Pre Bid Technical Clarification No.7 dated 17.05.2025 to NIB No.475 dtd 21.01.2025 for PKG-III EM Works of 186 MW Tato-I HEP

PROJECT LAND ZONE LAYOUT : TATO-I HEP

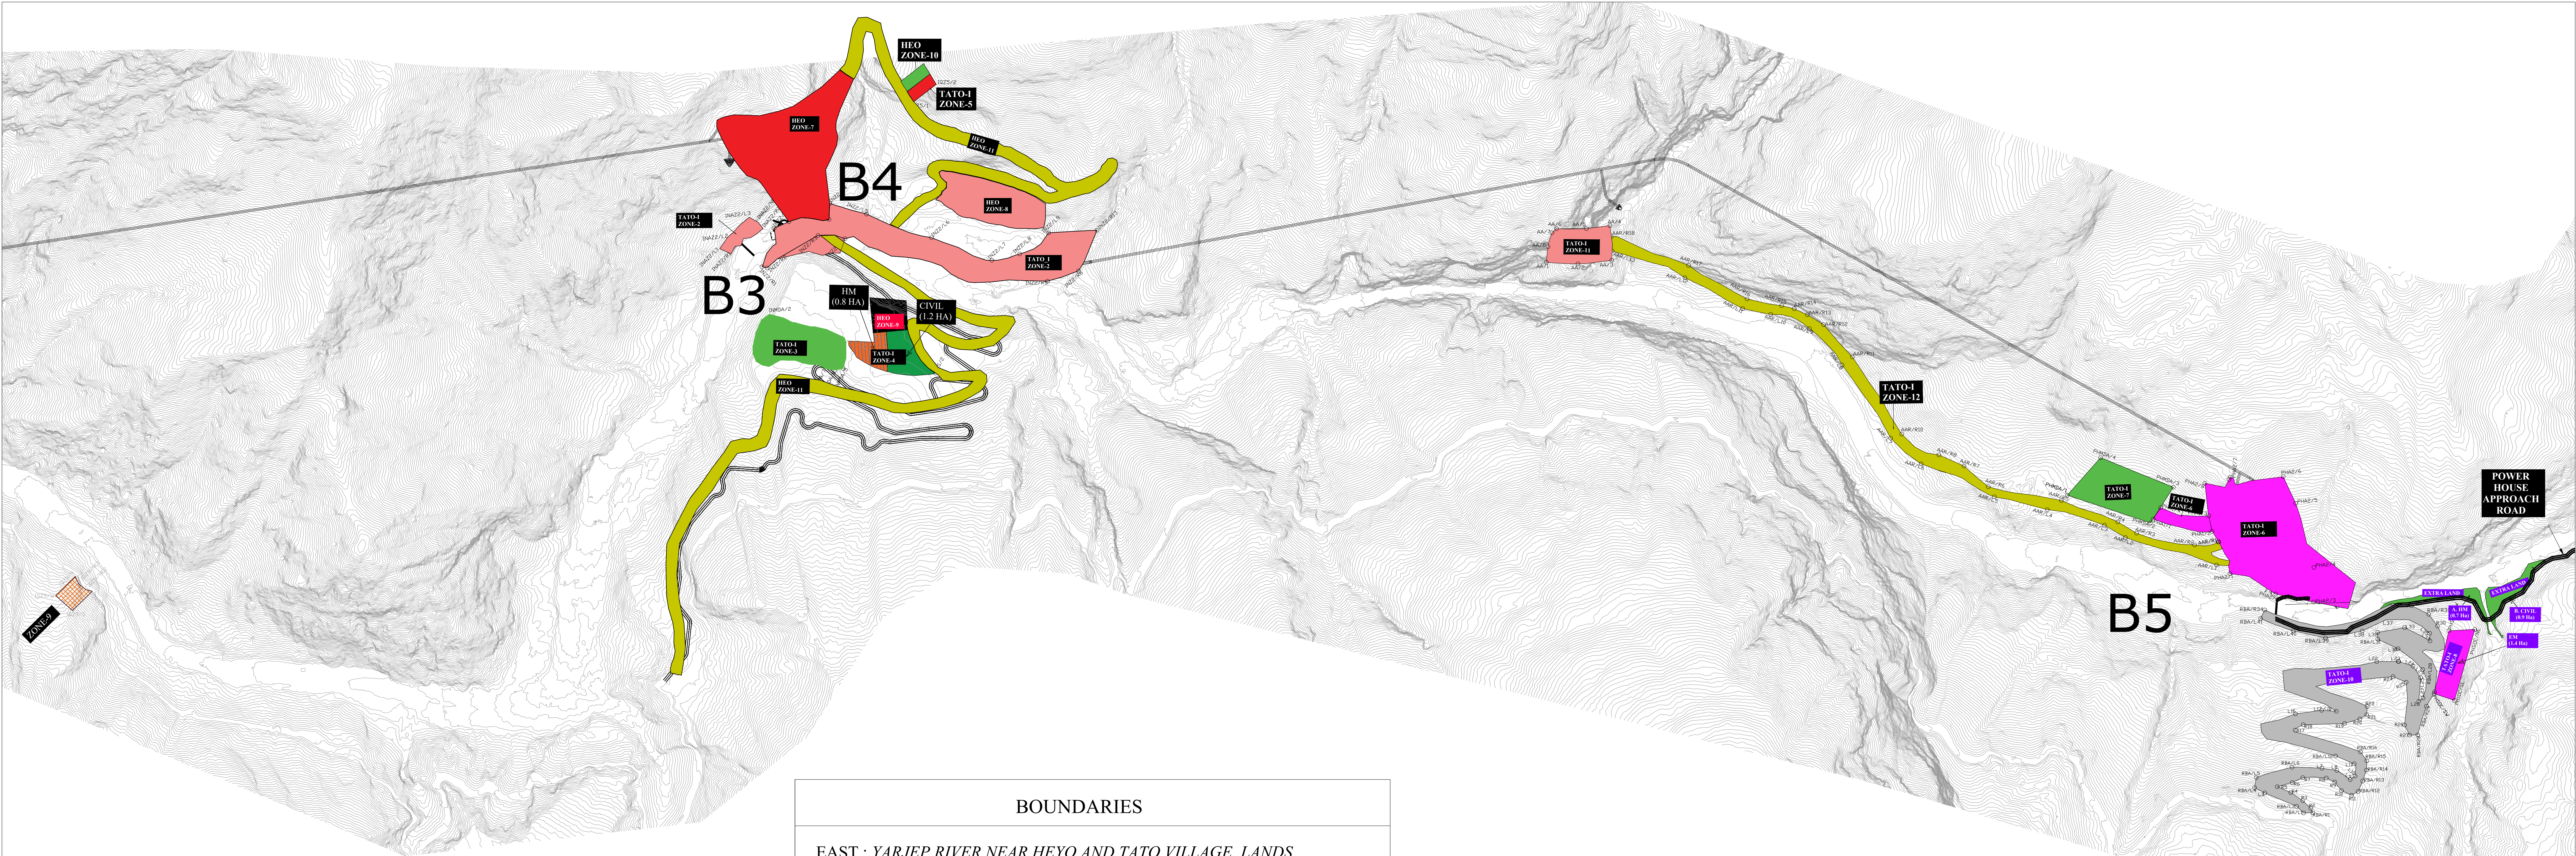
10	Volume II Sec- II/Sub-Sec-18 Illumination System	18.1	General	1	Lighting system for Power House area, GIS Building, outdoor areas around powerhouse, Pothead yard area, approach road near power house, Valve House, Intake area and its approach roads etc.	Tender is silent on length of the roads to be considered where the illumination is to be considered by the Bidder. Please clarify the same to consider accordingly.	Illumination requirement for approaches to Power House, Dam Site, Valve House, Pothead yard shall be 500 m each.
11	Volume II Sec- II/Sub-Sec-17 Earthing System	17.2	System Requirements	1	The intent of scope is to supply, install and supervise complete earthing system for Power House, Transformer area, Pothead yard area, Intake area and control room at Intake, valve house and adjoining functional areas.	It is requested to Kindly provide the soil resistivity of the following areas for Bidding purpose. In case soil resistivity is not available, please arrange to provide one reference value so that all bidder consider the same. Any upward variation in soil resistivity shall be subject to price implication. 1) Power House 2) Transformer Area 3) Pothead Yard Area 4) Intake Area 5) Valve House Area	The bidder shall have to measure the resistivity on his own and design the earthing system subsequent to the purchaser's approval Refer clause 17.5 of PTS, Vol-II, Sec-II, Sub-Sec-17.

Sl. No.	Name of the Road	Scope
1.	Approach Road from the Tato-Mechuka Road to the Right Abutment of the Bridge at d/s of the Tato-I Weir	Under NEEPCO's Scope (to be executed by Heo HEP EPC Contractor)

2.	Approach Road from the Tato-Monigong Road to the Right Abutment of the Bridge at u/s of the Tato-I Power House	Under Civil Contractor's Scope
3.	Approach Road from the left abutment of the bridge at d/s of the Tato-I Weir to the Tato-I HRT Intake	Under Civil Contractor's Scope

4.	Approach Road from the Left Abutment of the Bridge at u/s of the Tato-I Power House to the Tato-I Power House	Under Civil Contractor's Scope
5.	Approach Road from the Left Abutment of the Bridge at u/s of the Tato-I Power House to the Adit-1	Under Civil Contractor's Scope

6.	Approach Road from the Adit-I Road to Surge Shaft	Under Civil Contractor's Scope
7.	Approach Road from the Adit-I Road to Valve House	Under Civil Contractor's Scope
